Subject : Current Configurations of Pressure Suit and Parachute

The results of the meeting on January 16 thru 18 with regard to changes in the pressure suit and parachute are as follows:

FULL PRESSURE SUIT 1962
OXCART

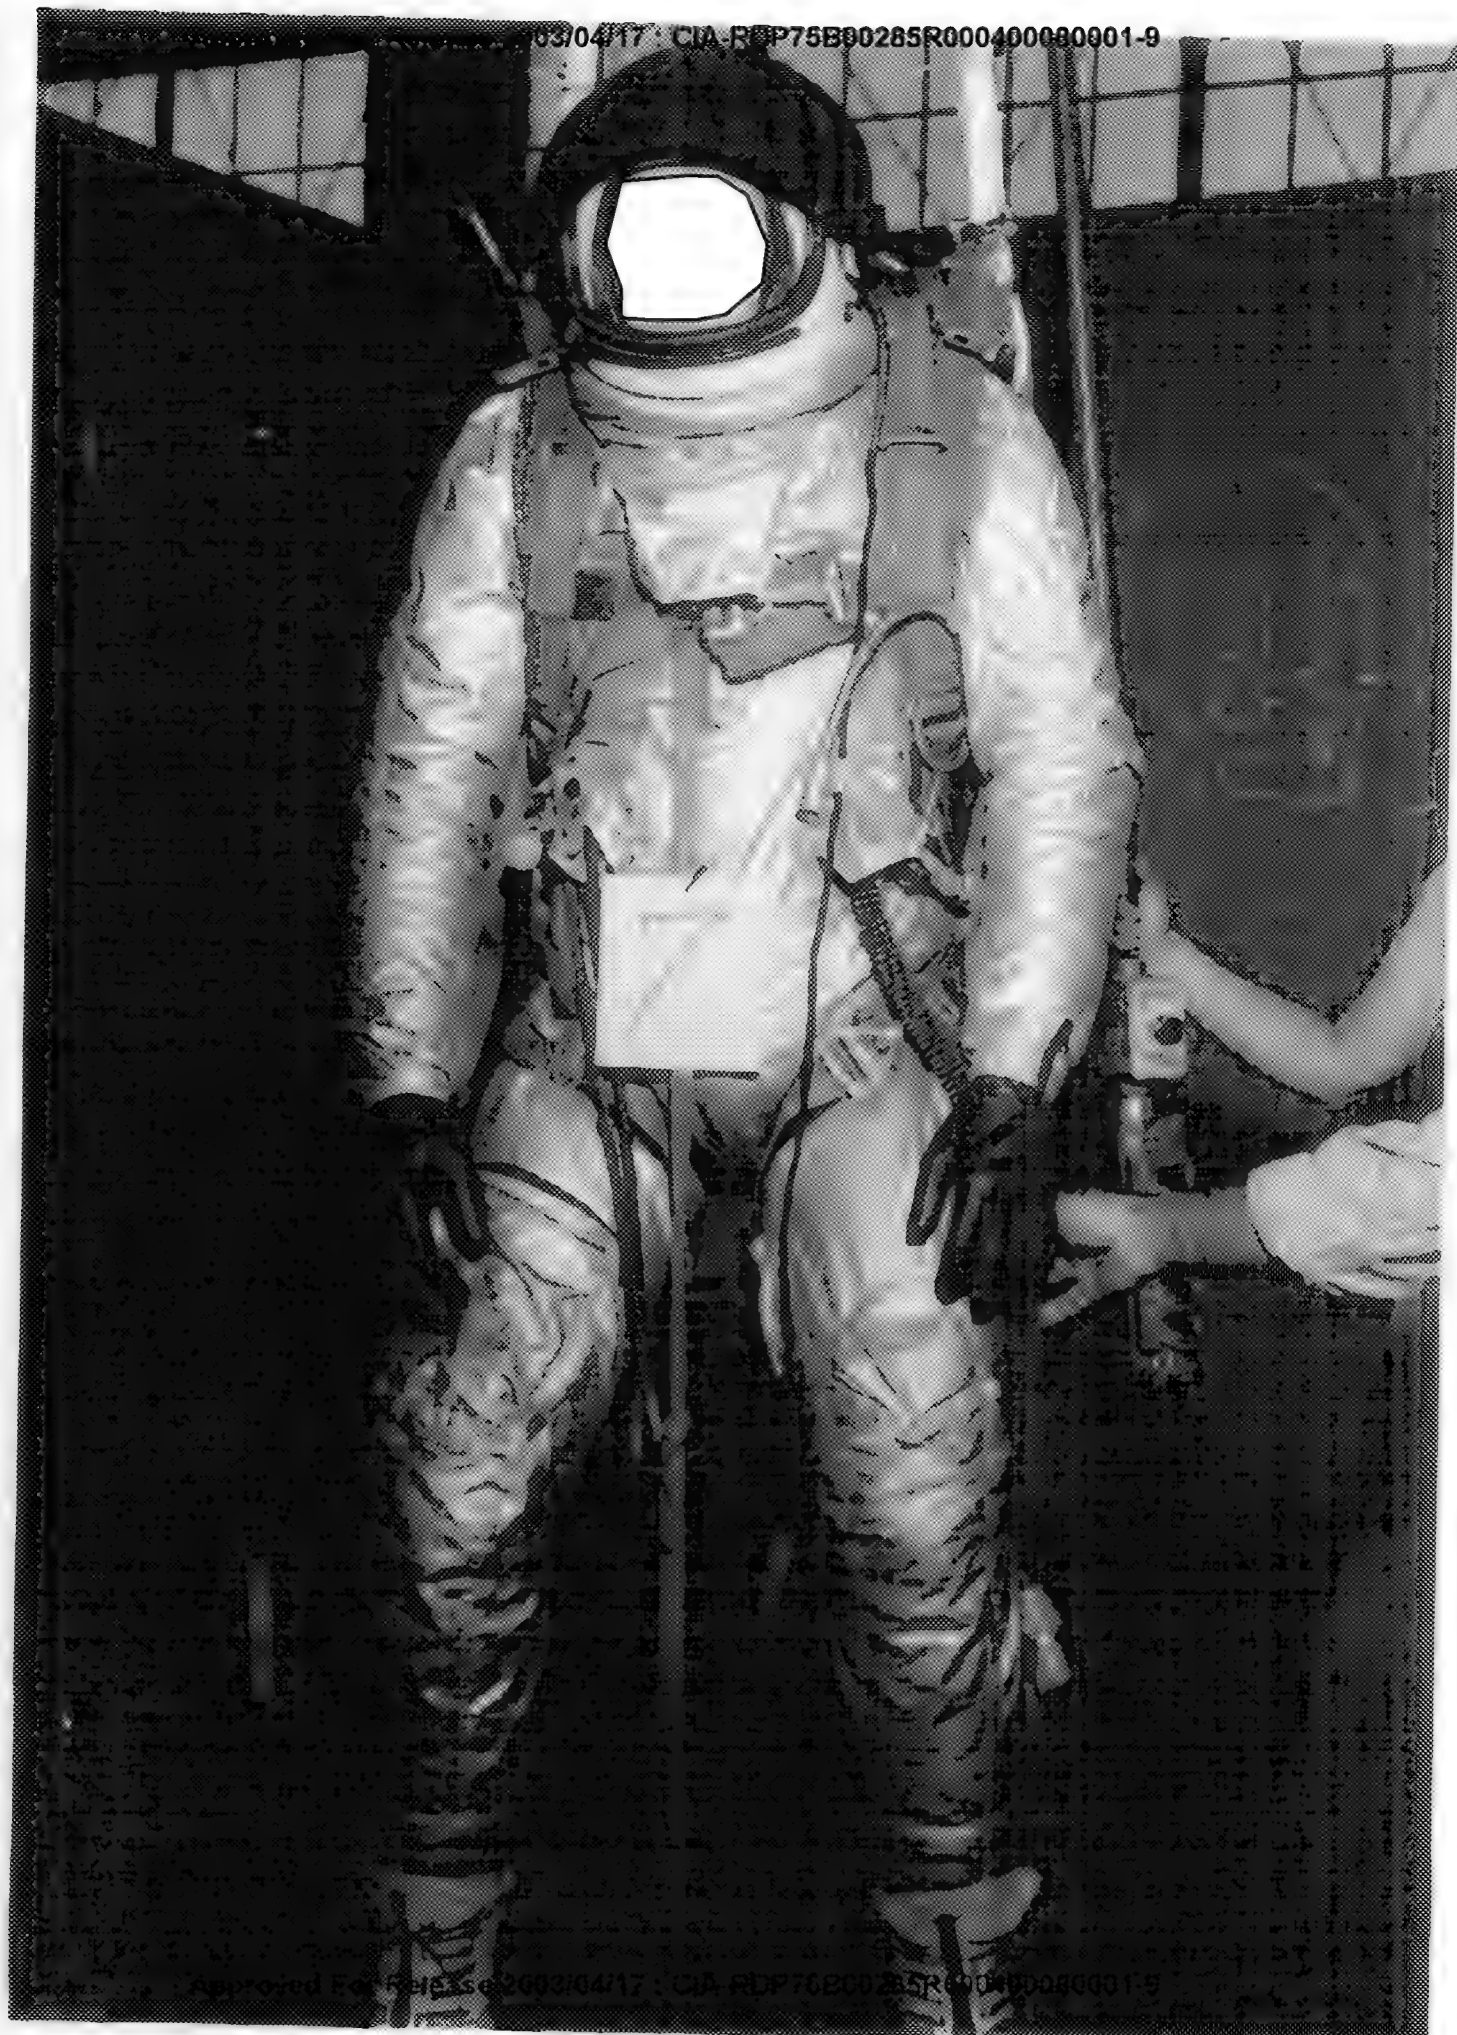
IN RIG WITHOUT
NECK COLLAR SPREADER IN FIN'D 1ST STAGE.
SUSPENSION POINT.

a) COMFORT BETTER THAN #5

b) SEEMS GOOD - NO CRITICISMS.

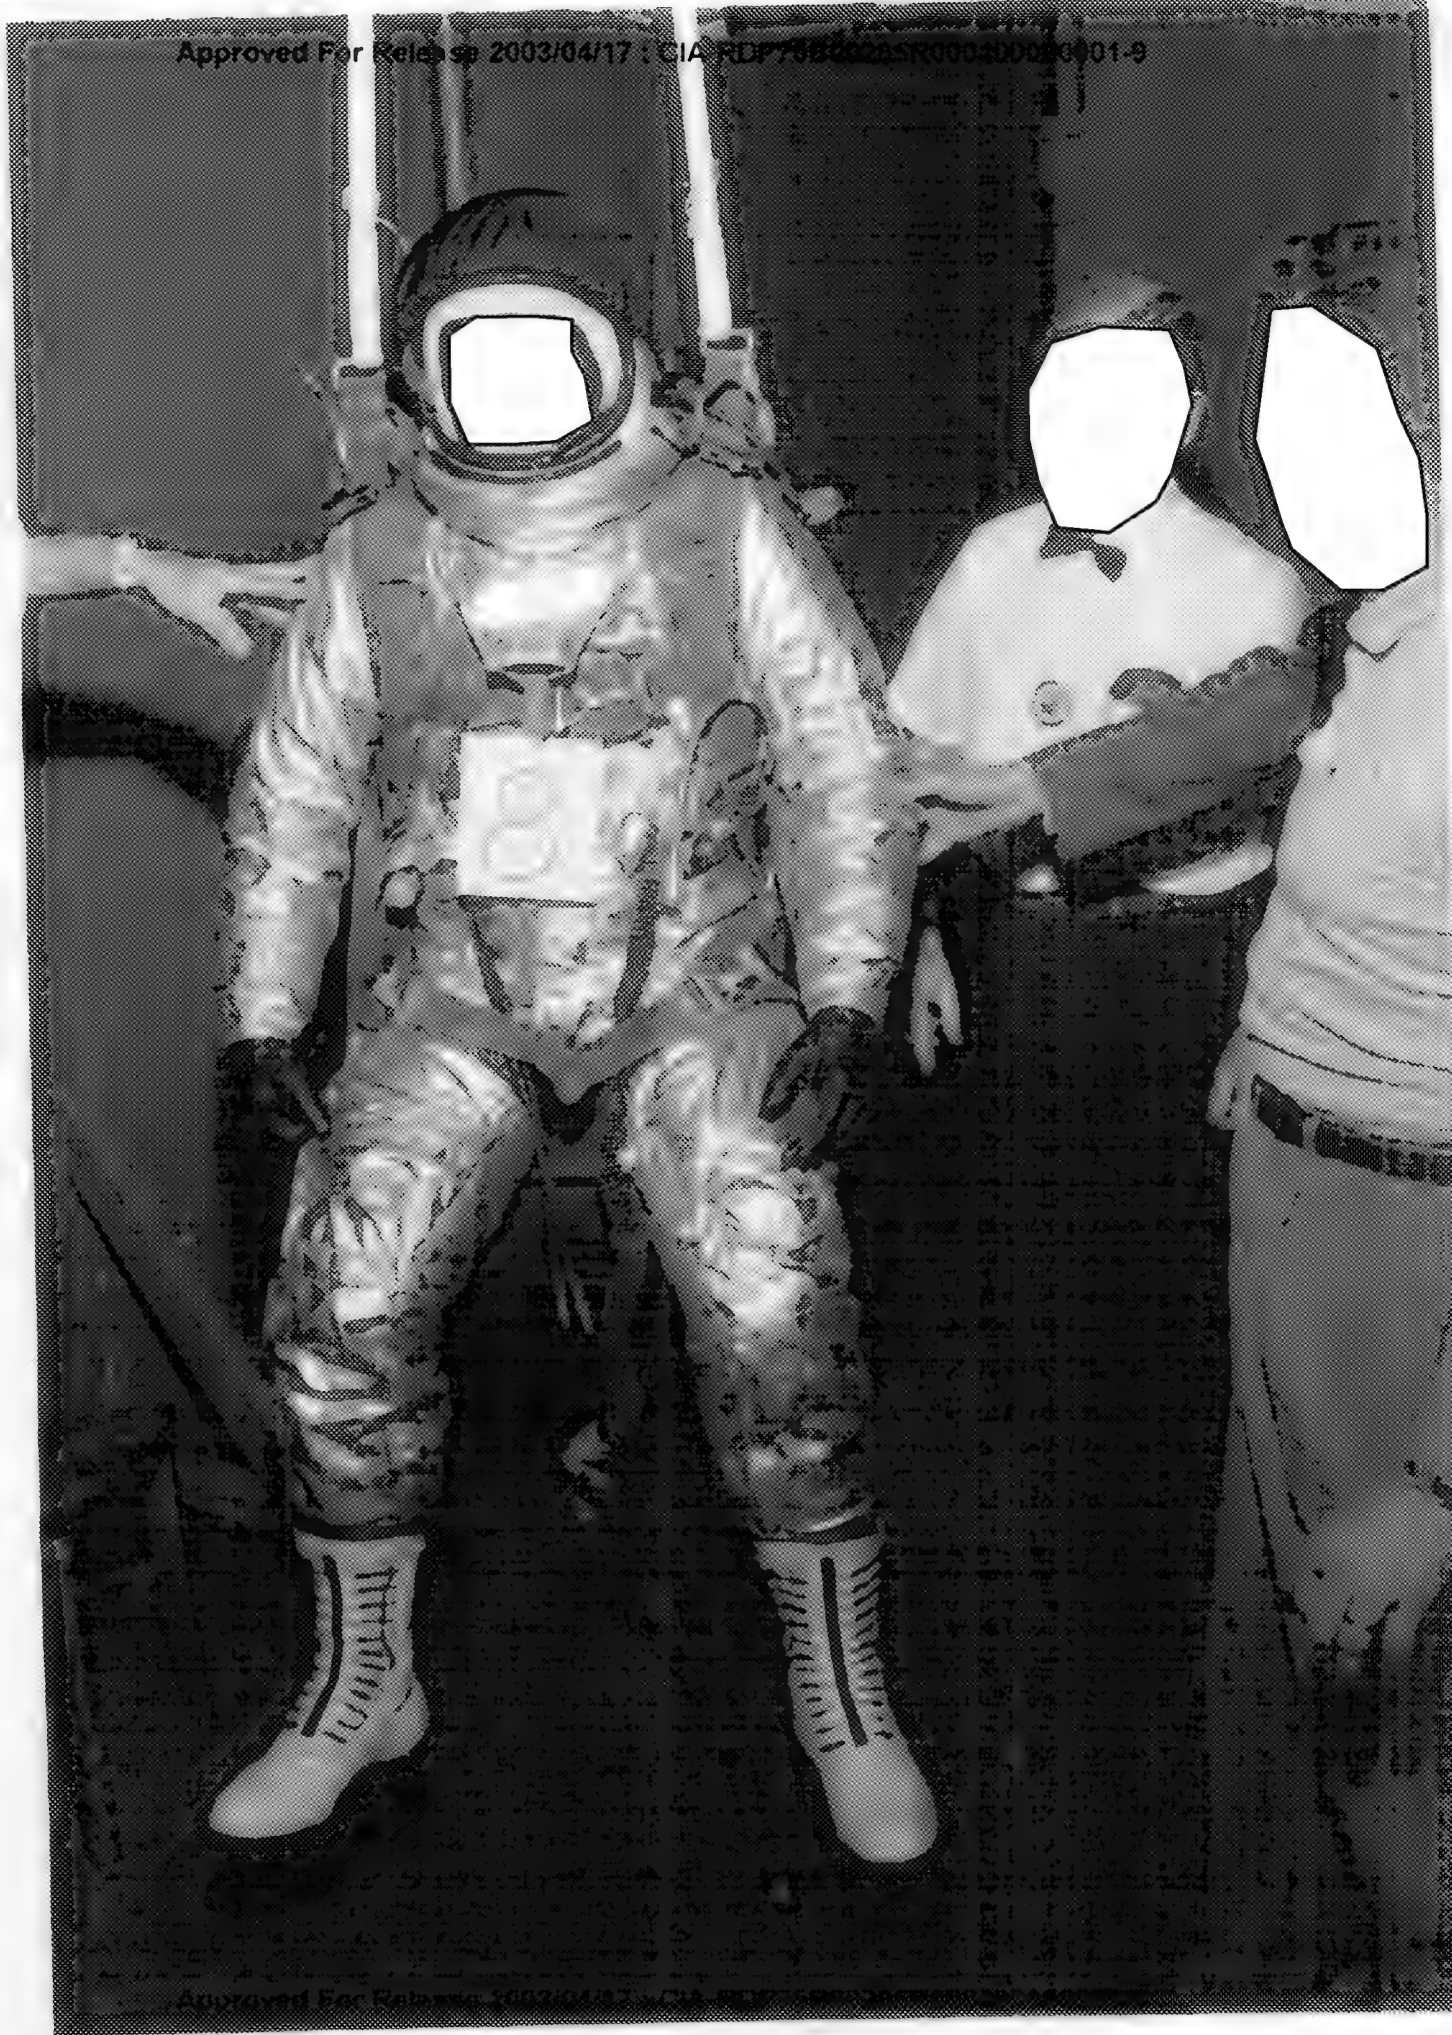
2. SUSPENSION 1ST STAGE IN AFT POSITION:

a) No OBJECTION ABLE CHEST PRESSURE

h) ... LEG ...

c) .. NECK

#8

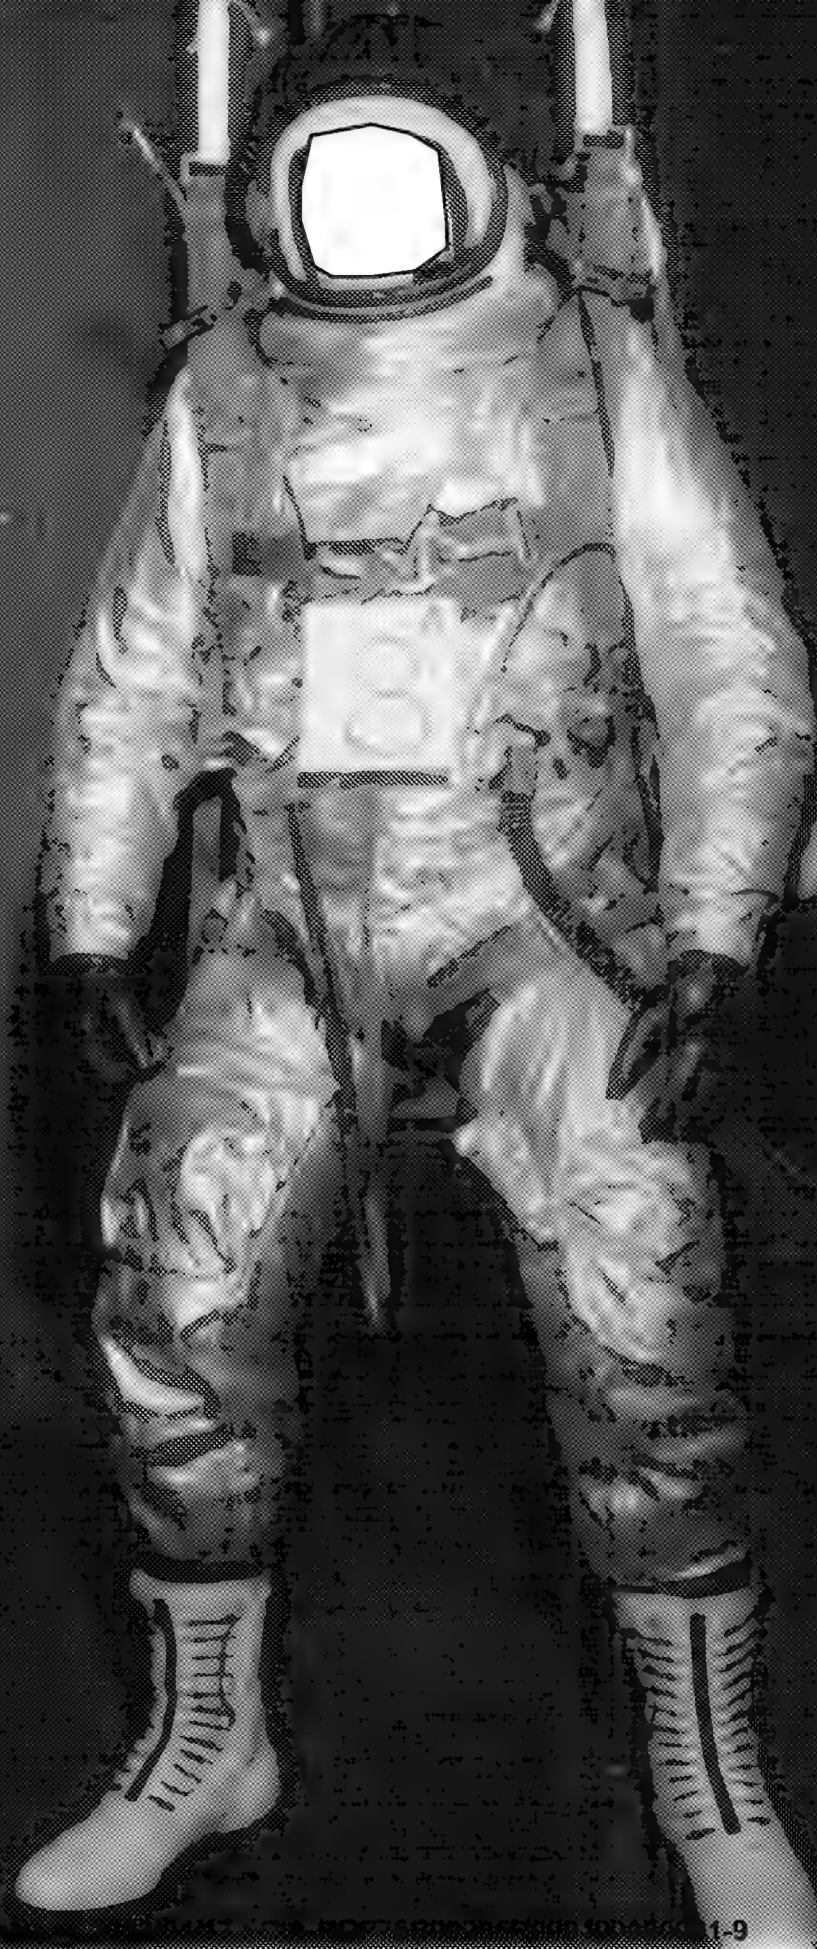
1. RIG WITHOUT NECK SPREADER COLLAR
2. SUSPENSION POINT SAME AS #7

- a) "I LIKE THIS ONE. BEST ONE SO FAR."

#9

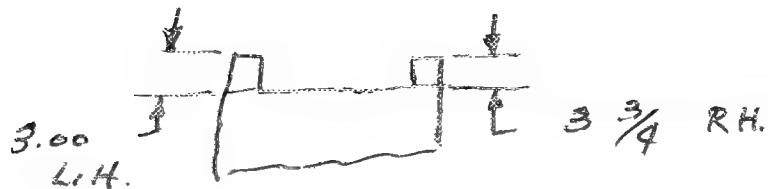
1. SAME RIG ~~DIFF~~ AS #8 WITH
1ST STAGE SUSPENSION FIW'D

a) FEELS ABOUT SAME AS #8

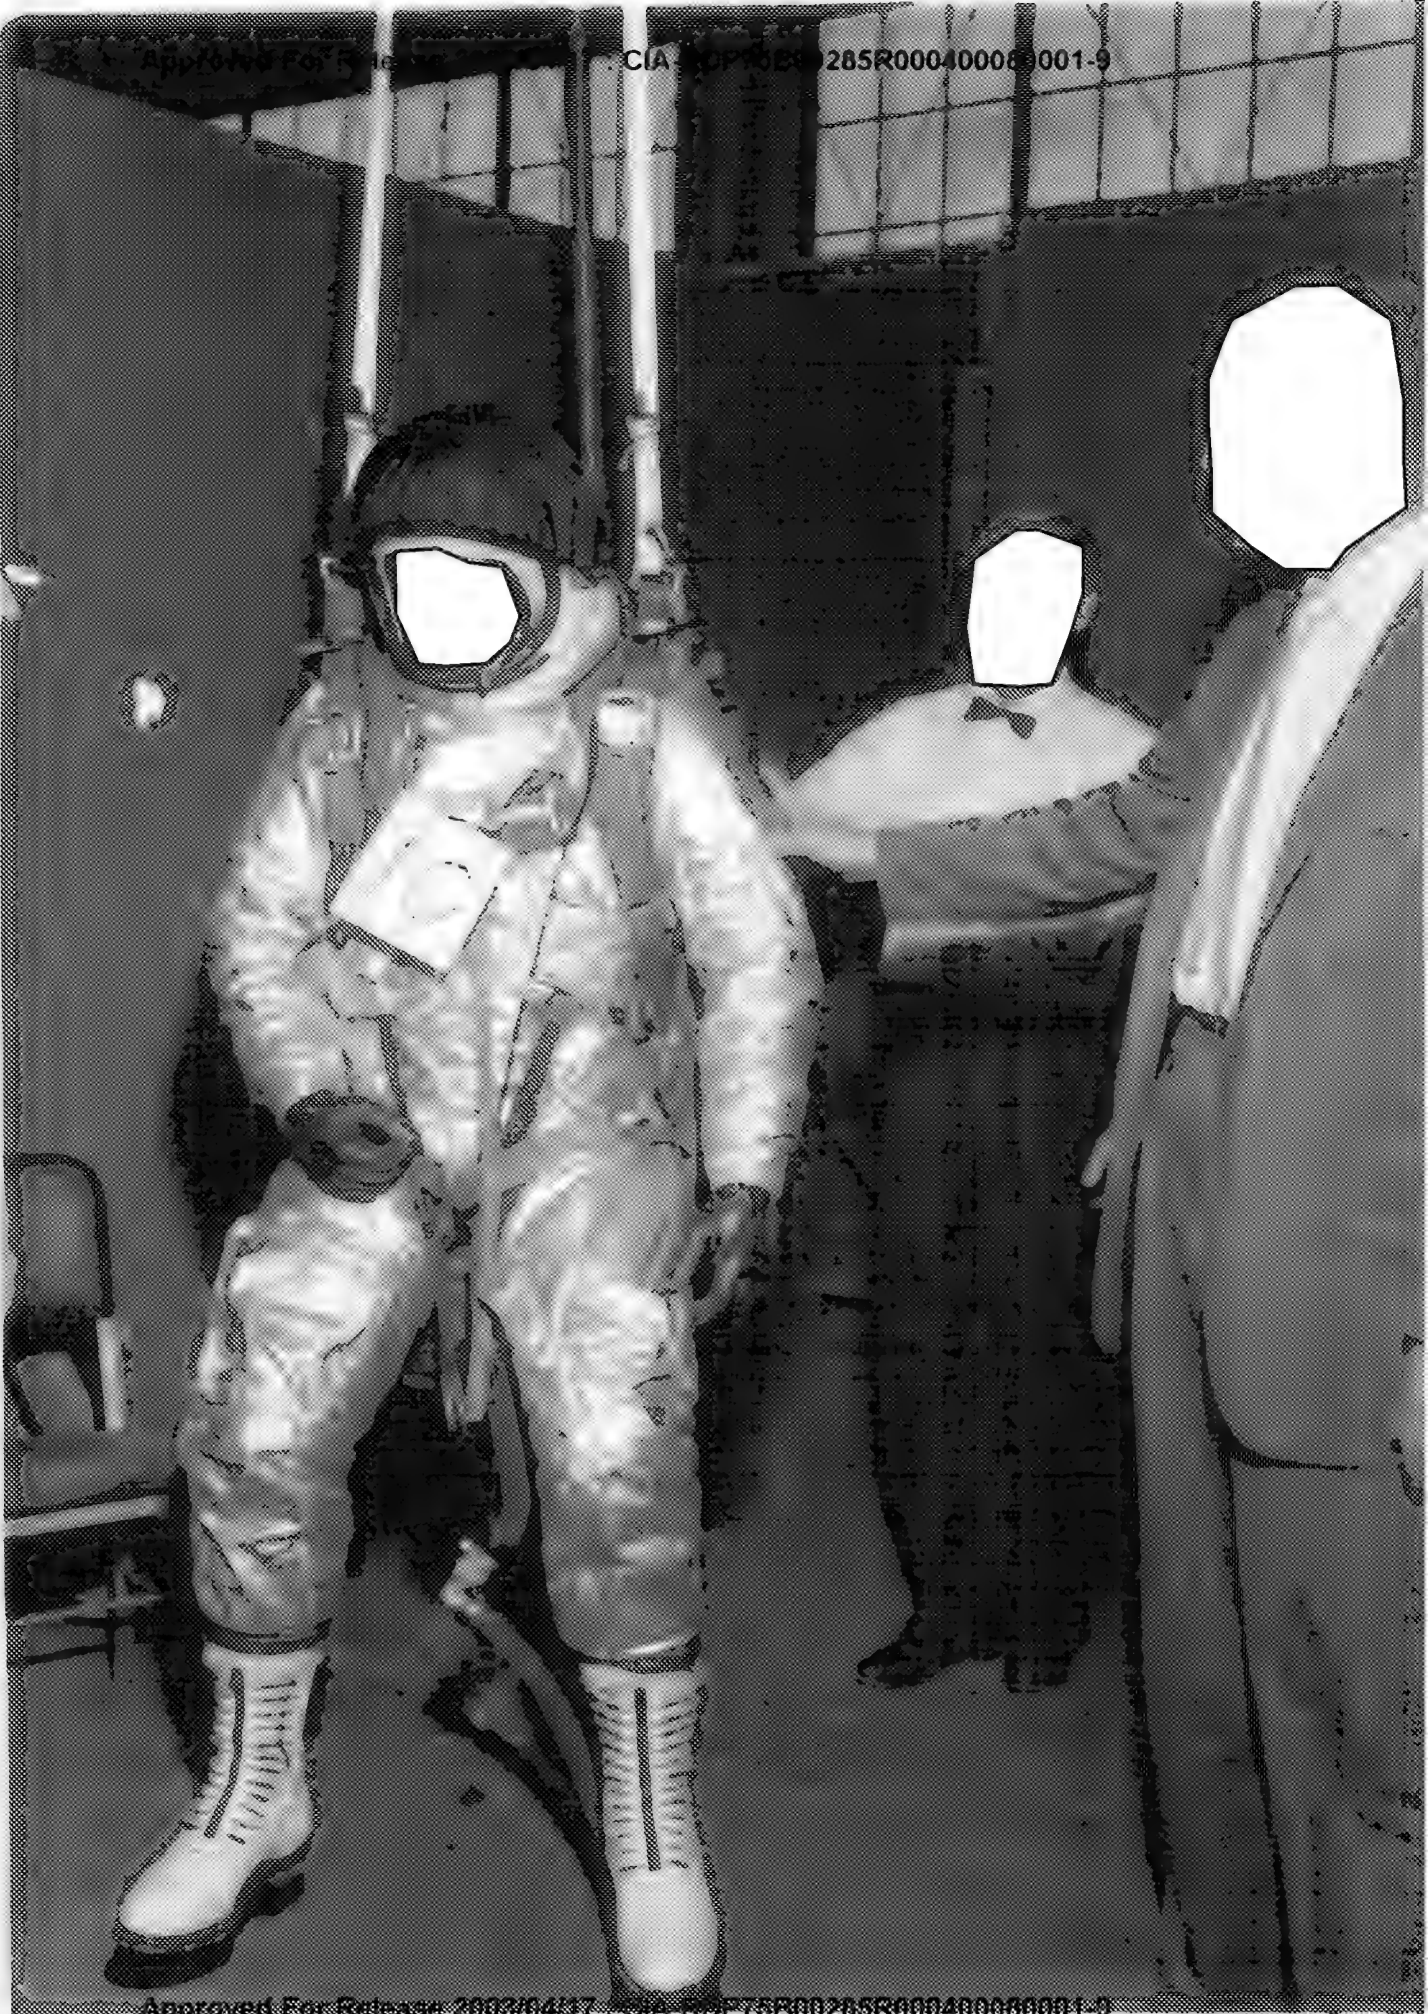
Q) RIG WITH NECK SPREADER

A) SUSPENSION IN FORWARD POSITION

Q) SUFFERING

A) STRAIN ON NECK

DOESN'T WANT TO JUMP -
HURTS TOO MUCH
